Addendum – Specialist input: Healthy Waters

Subject: FTA111 – Milldale Stages 4C and 10 - 13 Fast Track – Auckland Council
Application Reference: BUN60446761

Date: 23 July 2025

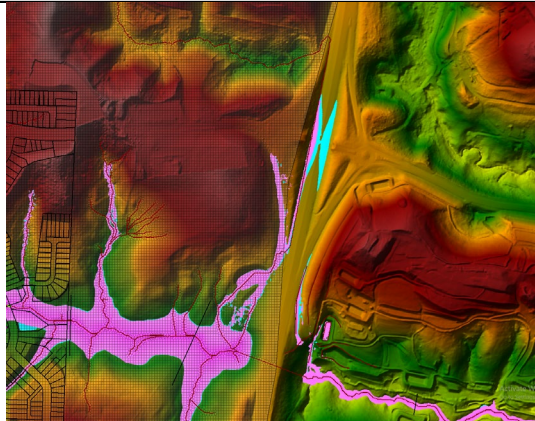
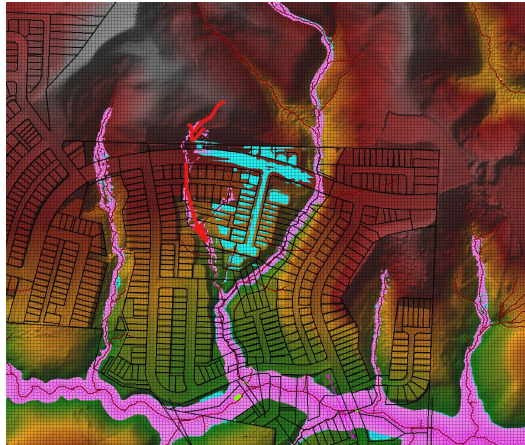
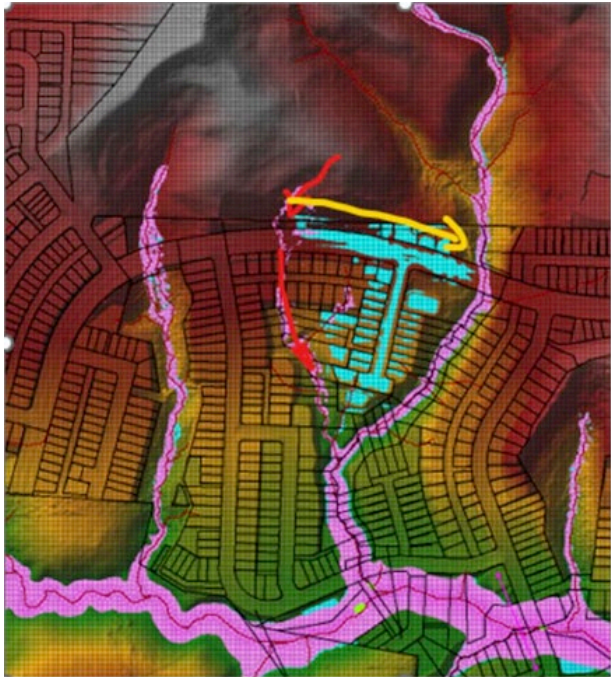
Catchment Planning – Flood Hazards					
SW11	Correct the use of 'inert' to low contaminant generating' building materials.	The use of inert building materials, is misleading. Studies have shown that commonly used inert materials are actually sources of heavy metals in stormwater runoff. Therefore, it is requested that 'low contaminant generating' building materials are used	Noted. The stormwater management approach for individual lots has been updated in the relevant reports to clarify the treatment sequence in accordance with GD01.	Noted. No further action	Closed

REF	HW REQUEST FOR INFORMATION/CLARIFICATION	REASON FOR REQUEST	APPLICANT RESPONSE – 02.07.2025	HW RESPONSE – 23.07.2025	STATUS
		<p>instead. The following consent condition can be used to assist in the control of building at the next stage of development and has been included within Appendix D.</p> <p><i>Stormwater Quality</i> <i>X.1 New buildings, and additions to buildings, must be constructed using cladding, roofing and spouting building materials that avoid the use of contaminant generating building products which have:</i></p> <ol style="list-style-type: none"> <i>exposed surface(s) or surface coating of metallic zinc or any alloy containing greater than 10% zinc; or</i> <i>exposed surface(s) or surface coating of metallic copper or any alloy containing greater than 10% copper; or</i> <i>exposed treated timber surface(s) or any roof material with a copper containing or zinc-containing algaecide.</i> <p>It should also be noted that in the Greenfield environment, the use of low contaminant generating materials is not considered a sufficient 'treatment' method and must be accompanied by a GD01 complaint device either at source or communally located.</p> <p>Where roof runoff utilizes either a first flush diversion device, or internally plumbed, non-potable reuse</p>	<p>Each lot will include the following features:</p> <ul style="list-style-type: none"> • A leaf diverter and first flush device installed upstream of any on-lot storage; • A retention/detention tank to manage both water quality and hydrological mitigation; and • A driveway treatment device, such as a 1m² on-lot raingarden or another GD01-approved alternative, to manage contaminants from hardstand areas. <p>This sequence ensures the first flush is captured and treated prior to detention, and that all lot-derived impervious surfaces receive appropriate treatment and mitigation in accordance with best practice. A consent notice will be registered on each title requiring installation, operation, and maintenance of these systems.</p>

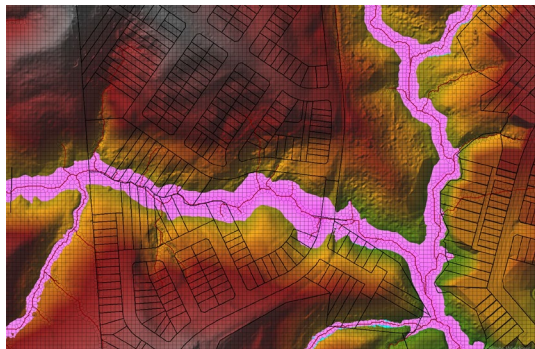
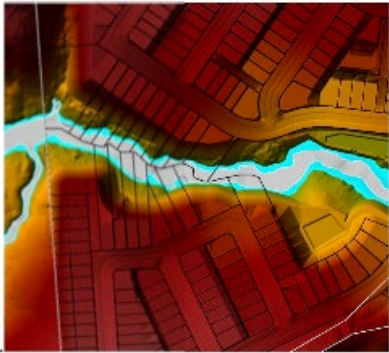
SW16	Public stormwater assets located within private lot areas and JOALS should be relocated within public space to allow long-term maintenance.	Some public lines (for example in the vicinity of JOAL04a) are located to the rear of private lots. There are issues that can arise from an ongoing operation and maintenance perspective of this arrangement, even when easements are applied. It is requested that the alignments of the public infrastructure be reconsidered as far as possible to reduce this situation occurring.	Where possible the lines have been located in the road reserve or public reserves. However due to layout and topography this is not always possible and practicable. A more refined adjustment of selected lines can be realigned in collaboration with Healthy Waters at EPA stage if required.	<p>We acknowledge that, due to site layout and topographical constraints, locating all public stormwater lines within road reserves or public reserves is not always feasible. However, it remains a priority that public stormwater infrastructure be located within public space wherever possible to facilitate efficient, long-term operation and maintenance.</p> <p>Public stormwater lines situated behind private lots, such as those near JOAL 04a, can create significant challenges for ongoing access, maintenance, and potential future upgrades even where easements are in place. This arrangement often results in increased complexity and risk for council and property owners alike.</p> <p>Given this, we strongly encourage you to undertake further refinement of the stormwater infrastructure alignment to minimize the extent of public lines within private lots. This should be</p>	Open

REF	HW REQUEST FOR INFORMATION/CLARIFICATION	REASON FOR REQUEST	APPLICANT RESPONSE – 02.07.2025	HW RESPONSE – 23.07.2025	STATUS
				<p>addressed early, with a view to optimizing layouts and considering practical alternatives.</p> <p>We understand that some adjustments can be further discussed and potentially resolved at the Engineering Plan Approval stage in collaboration with Healthy Waters. However, the resource consent application should clearly demonstrate efforts to locate public stormwater assets within public spaces as far as practicable and provide justification where this is not achievable.</p> <p>The stormwater plans and documentation should be updated accordingly to reflect these expectations.</p>	
SW17	<p>Confirm what newly created impervious areas are not receiving treatment or hydrology mitigation and provide a justification why they are not.</p> <p>Where areas are connected to the public network, demonstrate that they are accounted for in the appropriate raingarden.</p>	<p>Within the drawing set included in Appendix 12-3 there appears to be areas of new impervious coverage that are not receiving any treatment or hydrology mitigation.</p> <p>A relatively large area of Road 01 on the eastern side of Stage 1 appears to discharge untreated runoff to a stream gully, adjacent to a communal raingarden constructed on Road 09. This area of Road 01 contains two intersections and a change in grade. As a result, this area of the road will be subject to manoeuvring, braking and acceleration; all activities that increase the risk of contaminants being deposited on the road.</p> <p>There are also some JOAL areas that appear to not be accounted for in the raingarden design despite being connected to the public network.</p>	<p>As per response to SW5 above.</p> <p>All new impervious areas across the development are accounted for in the stormwater management design and receive appropriate water quality treatment and hydrology mitigation in accordance with GD01.</p> <p>Public roads and JOALs are treated via communal raingardens, each sized to manage the Water Quality Volume (WQV) and mitigate the 95th percentile storm event:</p> <ul style="list-style-type: none"> • JOAL 1 → RG04 • JOAL 16 → RG14 • Road 1 → RG02 and RG12 <p>Private lots are managed at source, with each lot required to:</p> <ul style="list-style-type: none"> • Treat runoff via first flush diversion, • Provide on-lot retention/detention tanks, and • Incorporate a GD01-compliant driveway treatment device (e.g. stormfilter or raingarden). <p>No new impervious areas are proposed that bypass treatment. The catchment plans (Drawings 3725- 1-4310 and 3725-2-4310) and the stormwater calculations attached confirm that all impervious surfaces are directed to appropriate treatment devices and sized using confirmed runoff coefficients.</p> <p>This ensures full compliance with treatment and hydrology mitigation requirements for both public and private components of the development.</p>	<p>Refer SW 5.</p>	-
